INDESIT company

Model type:
MB4033NFIT

Commercial code:
F029467

n1030059: Modification of freezer doors on Ariston Opera-60 combined fridge-freezers (cond

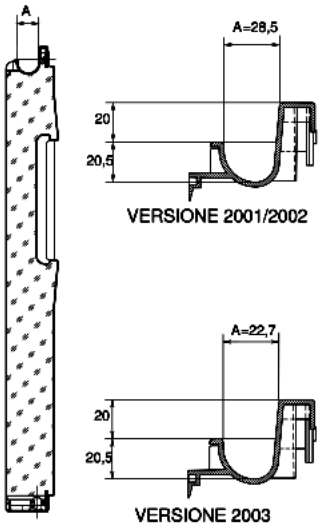
In March 2003 the Melano factory started using freezer doors with modified handle on the Ariston Opera-60 combined fridge-freezers (models MB-MBA-MBAA), in order to eliminate the problem of condensation.
The grip width has been reduced (from 28.5 to 22.7 mm) on these doors, as indicated by the dimension (A) in the figure (N1030059FIG1).
These freezer doors are already available as replacements and a coloured label on the packing distinguishes them from the previous ones. This will be done until stocks of premodification doors run out.
The codes of the freezer doors have not been changed:

Models (MBAA3811)
C00089881 - FREEZER DOOR-ROUNDED /NEW WHITE 592x713x81

Models (MBA3332-MBA3832-MBA3842-MBA4042 / MB3822-MB4022)
C00081999 - FREEZER DOOR- ROUNDED/NEW S/STEEL 592x713x81

Models (MBA3833- MBA4033)
C00083757 - FREEZER DOOR- ROUNDED/NEW SILVER 592x713x81

Models (MBA3835- MB4035)
C00084420 - FREEZER DOOR- ROUNDED/NEW 1003-YELLOW 592x713x81

Models (MBA3835- MBA4035)

C00084430 - FREEZER DOOR- ROUNDED/NEW BLUE 592x713x81 (MBA3835-4035)

Models (MBA3311-MBA3331-MBA3811-MBA3821-MBA3831-MBA3818-MBA3841) (MBA3841-MBA4021-MBA4031-MBA4041) (MB3321-MB3811-MB3821)

C00081997 - FREEZER DOOR- ROUNDED/NEW WHITE 592x713x81

n1030067: Noisy freezer compartment fan in Ariston and Indesit Opera-60 total no-frost fri

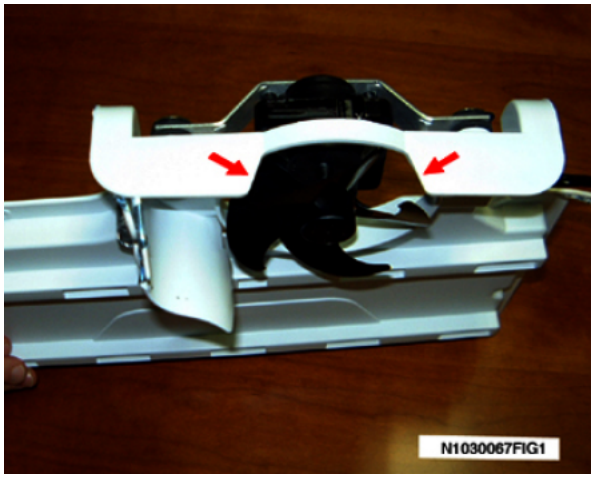
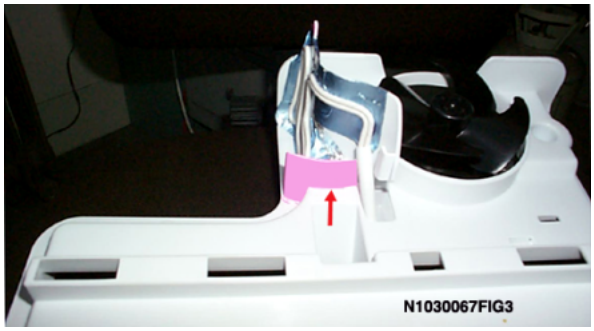
On Ariston and Indesit Opera60 Total No Frost fridge-freezers produced before August 2003, the freezer fan may stop due to ice build-up (stalactites), activating the alarm.
The problem has been solved by emptying the conveyor (chamber separator) in the upper part to give the fan more space (see fig.1).

To solve the problem in products in use, an air conveyor kit (Sat code 094490), which also includes modifications to reduce dispersion air flow, has been introduced since 25/9/2003 (see fig.2) and 06/10/2003 (see fig.3).

n1030068: Low fridge compartment temperatures in Ariston and Indesit Opera-60 Total No Fro

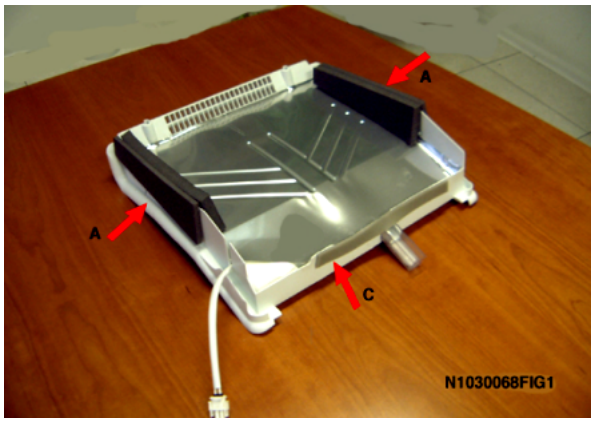
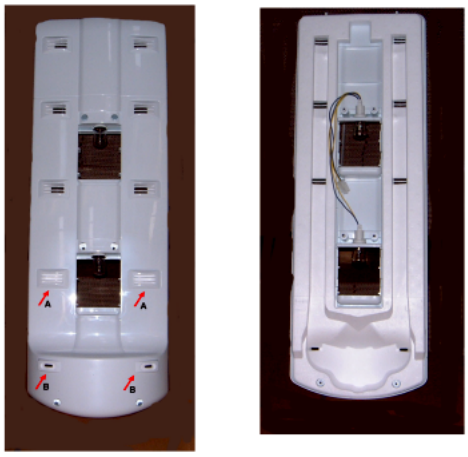
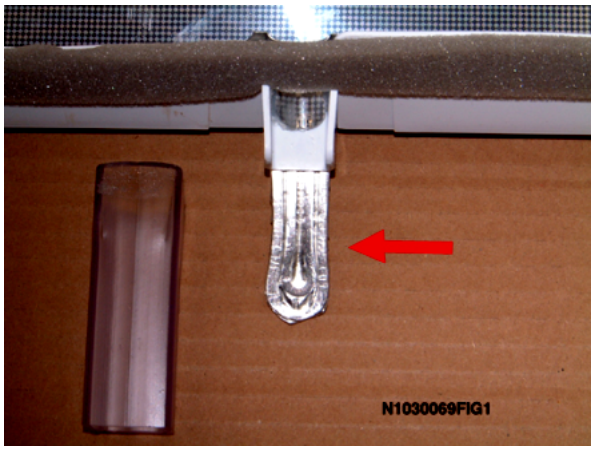
In Ariston and Indesit Opera-60 Total No Frost fridge-freezers produced before June 2003, there may be a lowering of the fridge compartment temperature in the crisper area (with freezing of food) due to the backflow of cold air from the freezer.
This problem generally occurs when the "super freezer 24 or 48 hours" function is set.
The problem has been solved as follows:

2) The lower vents on the multiflow have been closed from the inside (see fig.3/4-ref.A) and the outlet of those located in the curved area has been reduced (see fig3/4- ref.B). To solve the problem on products in use there are two spare part kits: 094675 for the version with three outlets, and 094737 for that with four.

3) The two side sponges on the freezer separator have been lengthened (see fig1-ref. A) and another has been fitted at the back, in the outlet hole area (see fig.1-ref C). Kit 097661 is managed to solve the problem on products in use. This kit includes a double filament resistance (see note N1030069).

KIT 094675 N1030068FIG3

KIT 094737 N1030068FIG4

n1030069: Freezer compartment drip hole obstructed on Opera60 Total No Frost fridge-freeze

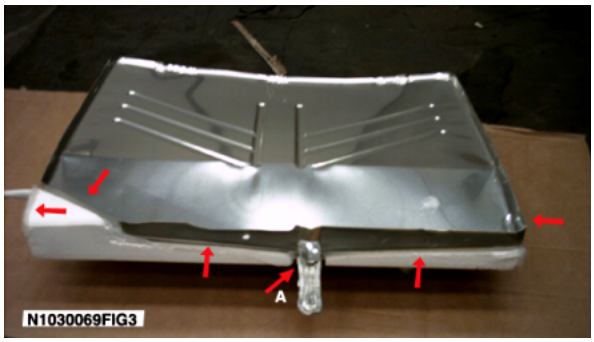
On Ariston and Indesit Opera60 Total No Frost fridge- freezers produced before June 2003, the freezer separator drip hole may be obstructed due to ice build-up.

The problem has been solved by fitting a double filament resistance at the end part, which can be seen by removing the rubber protection. (see fig. 1). The resistance is glued to the drip (see fig. 2).
Freezer separator Sat code 094485, complete with modified resistance, is managed as a replacement to solve the problem on products in use.

If the 40W resistance needs replacing it will be necessary to restore the sealing, located in the hole area, using silicone (see fig3 - ref A).
Also, to protect the separator from possible water penetration, silicone is used to protect the drip with polystyrene insulation at the back, and also the right corner, relevant to the wiring outlet is protected with silicone in the upper part.

N1030079FIG2

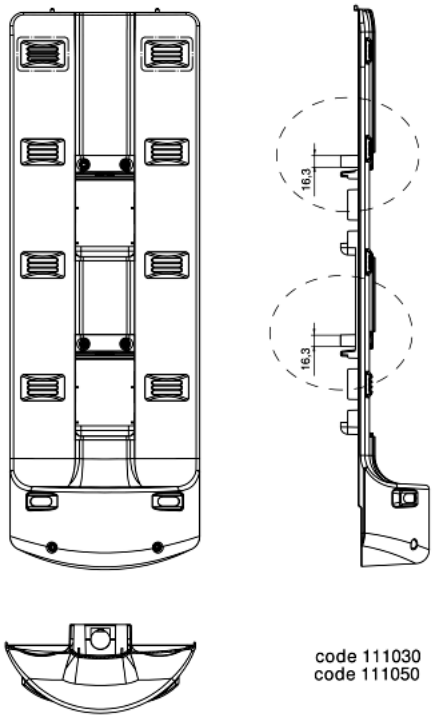
In June 2004 (serial no. 40604.0001), the Melano factory modified the multiflow fixing system to the shell on Ariston and Indesit Opera-60 Total No Frost fridge-freezers.
The inner wall of premodification models featured four square marks (20x20) in the central area for fixing the multiflow cover. The four marks have been eliminated and the wall only features the position for the holes.
Furthermore, the head of the four pins that house the fixing screws on the multiflow cover have been modified. Premodification items ended with an external diameter of 9 mm, whereas the current version has a diameter of 16.3 mm (see figures N1030079FIG1 and FIG2).
The new multiflow cover can be mounted on premodification models but not vice versa, paying attention not to overtighten the screws as the pins may break. If necessary, bush 039567 can be used as stopper.
The multiflow cover is managed as Kit to solve the problem, on products in use, of the formation of condensation on the vegetable basket due to the inflow of cold air from the freezer (see note N1030068).

111030 - 4-way multiflow cover KIT (serial no. 40604.0001)

111050 - 3-way multiflow cover KIT (serial no. 40717.0001).

094737 - 4-way multiflow cover KIT
094675 - 3-way multiflow cover KIT

n1030085: New freezer evaporator on Ariston/Indesit total no frost 60 cm fridge-freezers

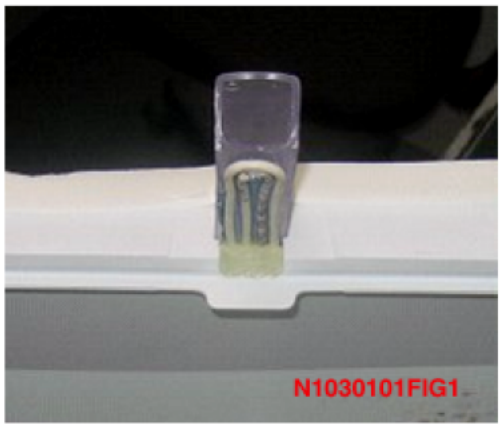
In October 2004, the Melano factory modified the freezer evaporator and return tube on Ariston and Indesit Opera-60 total no frost fridge-freezers, in order to improve the connection.

Now the return tube is straight (outer diameter 6 mm), whereas previously it had a socket end 15 mm long (outer diameter 6.35 mm).
Before the modification, the coil tube on the freezer evaporator (outer diameter 8 mm) was straight, now it has a tapered end section 15 mm long (outer diameter 7.6 / inner 6.2 mm) to insert the return tube.
If the evaporator needs replacing, it will be necessary to connect it with a Lokring connector 7.5/6 NRAL50 (058213) or 7.5/6NRMS00 (058203).

If tightness is lost when the ring is removed, it will be necessary to use connector 8/6 NRAL50 (058214) or 8/6 NRNS00 (042050).

The new freezer evaportor can be fitted on premodification appliances, but once the ring is removed, the 6 mm outer diameter must be restored on the return tube (check that it is long enough to be able to use the pliers to connect the 7.5/6 ring).

113845 - NOFROST FREEZER EVAPORATOR ASSEMBLY R600/R134a

094667 - NOFROST FREEZER EVAPORATOR ASSEMBLY R600/R134a
